Community Plan For Holloway's (CP4H) role has been to amplify the voices of the thousands of local residents it has engaged with since May 2018, who have expressed views and concerns about the development of the Holloway site. This response is on behalf of the CP4H Board ('we').

We would like to express our objection to several aspects of the proposal for the redevelopment of the Holloway Prison site. The objections are numerous, in many instances material and in direct contravention of the SPD, the Local Plan, the London Plan and national planning policy.

Time in Sun Analysis Results – June 21st

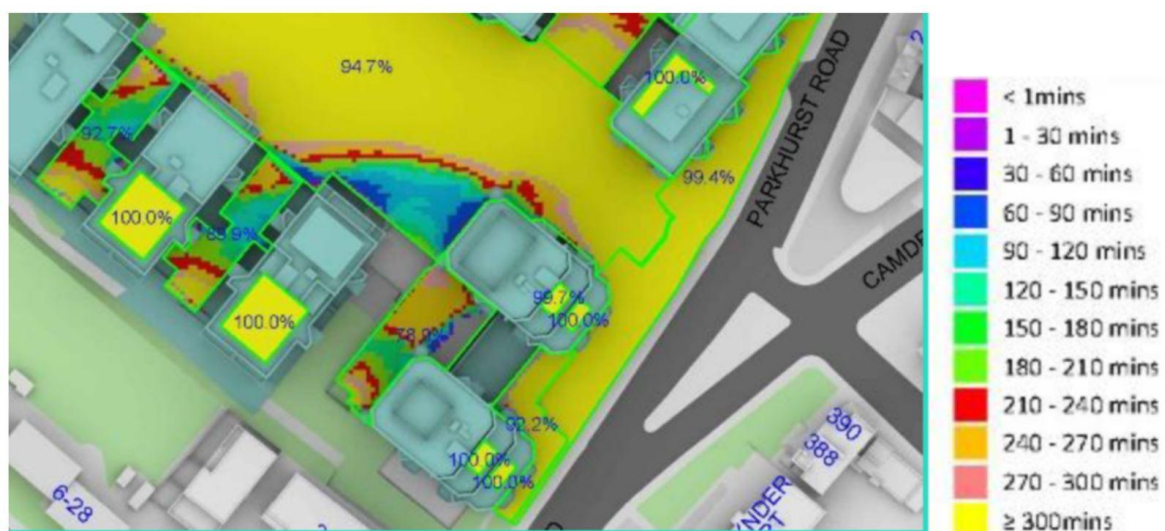
The Women's Building Garden will not be the lush, tranquil, contemplative space described. For such an important amenity space it will receive a very low level of sun on ground. The BRE target for an amenity space establishes only a minimum performance level and it is only just met when an average is taken across the full garden area. The specific amenity areas for seating and crèche use by the back entrance can be seen to never receive any sun (on the image below) while the remainder of the garden will be overshadowed, receiving considerably less sunlight than would be expected for a prime garden space. The garden is also overlooked by 3 tower blocks; will suffer from downdrafts that make seating uncomfortable; is adjacent to the crèche and is near the main road, all of which may be trauma-triggering for some women.
